# Dewberry Response to USGS Review of the Texas West Central Block 04 LiDAR Project

Produced for U.S. Geological Survey

USGS Contract: G10PC00020

Report Date: 05/31/2019

Figure 3-Tiles 13RGR740430 AND 13RGR725430. After minor corrections were done. The low area (pit) was left in as ground.

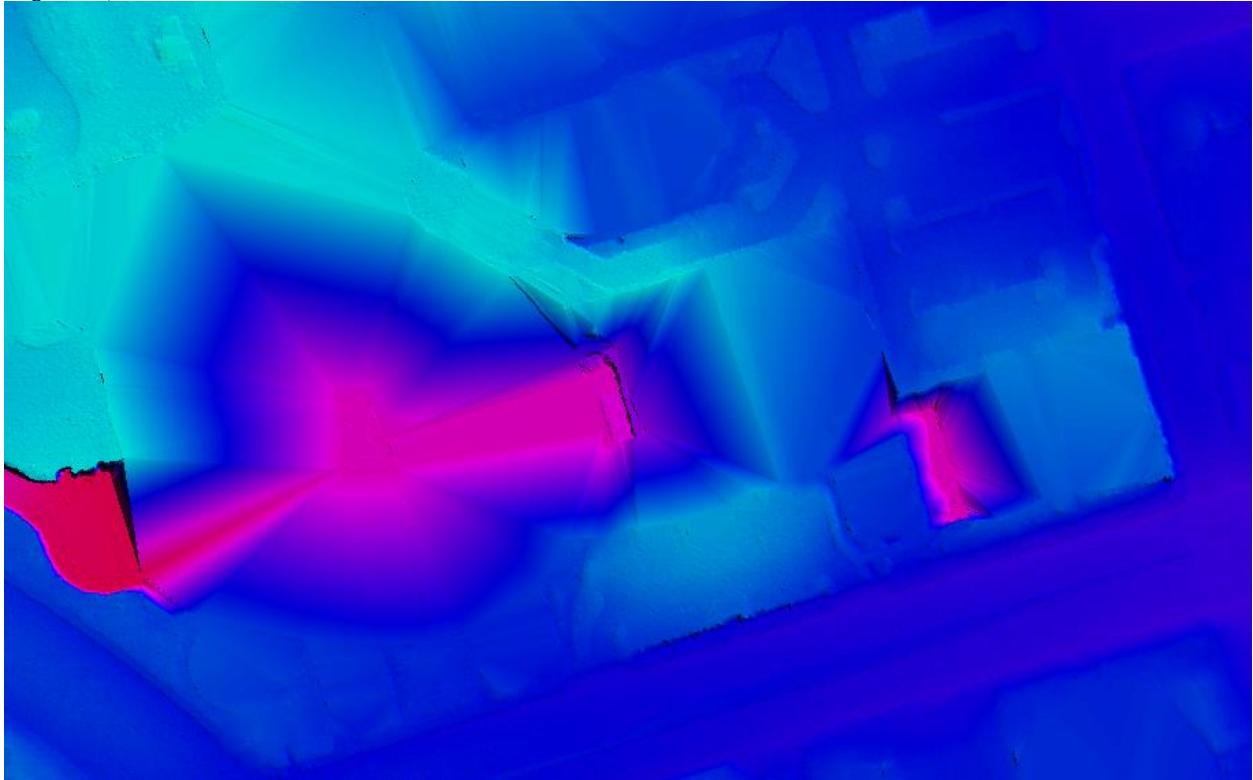
USGS made one call for a pit identified where a building was removed. Dewberry determined that the low areas were court yards and represented the ground. Therefore some cleanup was introduced but the low areas (pits) were left in as ground.

Figure 4-Tiles 13RGR740430 and 13RGR725430. The image on top is the Midland Memorial Hospital in Midland, Texas. The image on the bottom is a closer view of the hospital and a better view of the courtyards where trees can be identified.

Figure 5 – Tile 13SGR755475, before bridge removal.

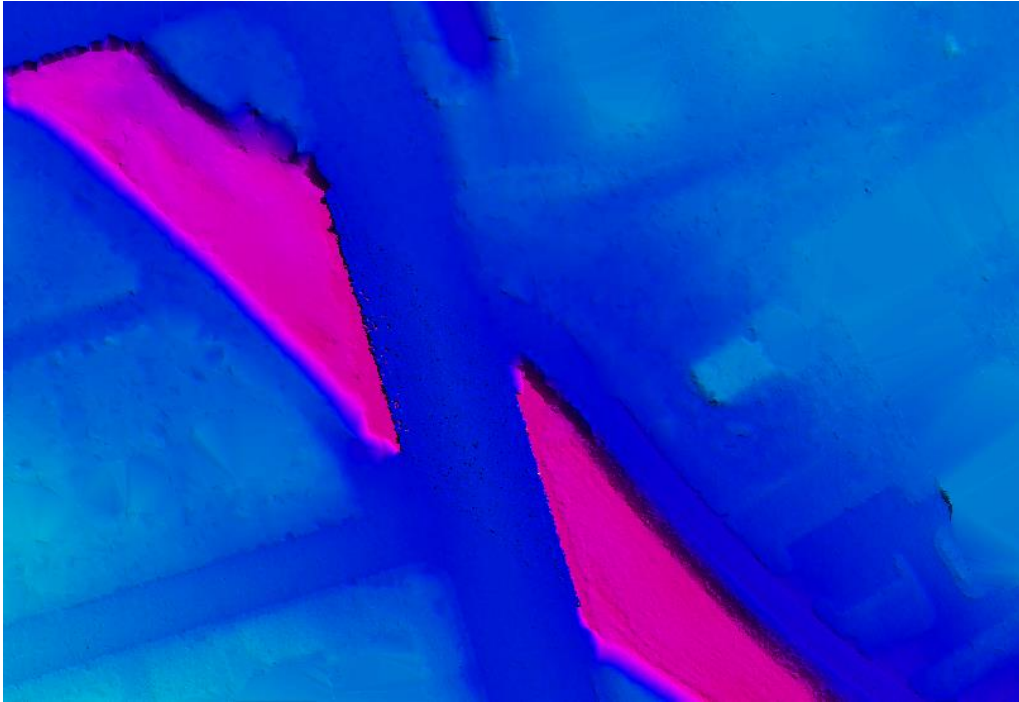
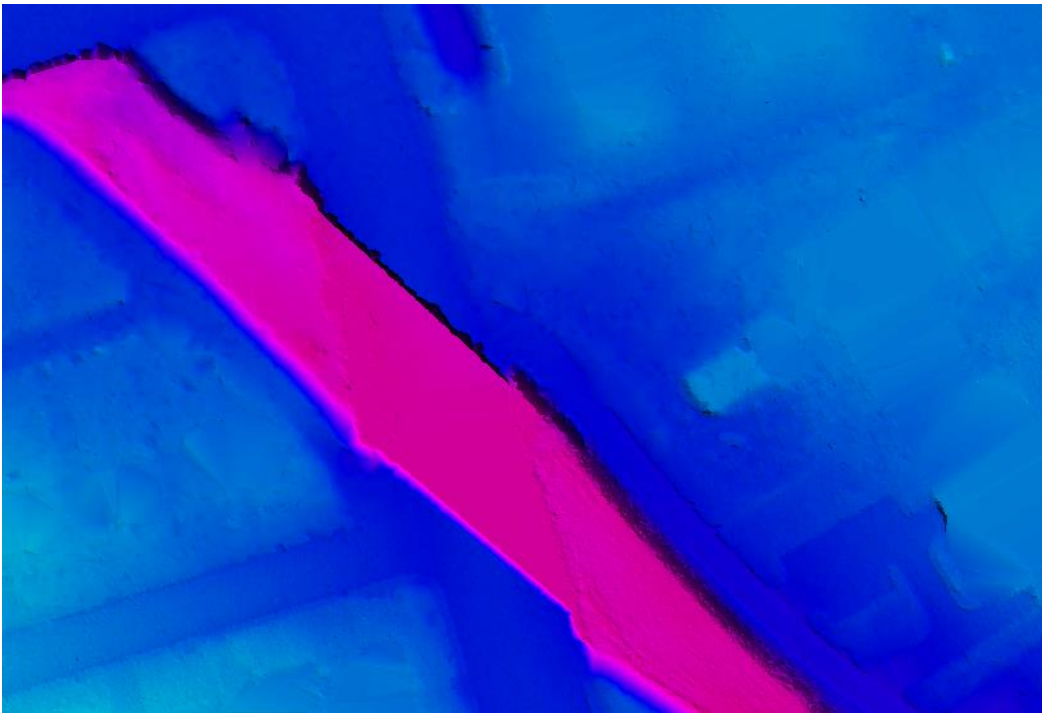
USGS identified three bridges as being left in the ground model. Dewberry has reclassified two of the bridges to Class 17 Bridge Class and added bridge saddle breaklines to remove the saddles. One call was determined to be a culvert and no action was taken.

Figure 6- Tile 13SGR755475, the bridge has been removed from the Lidar and DEM.
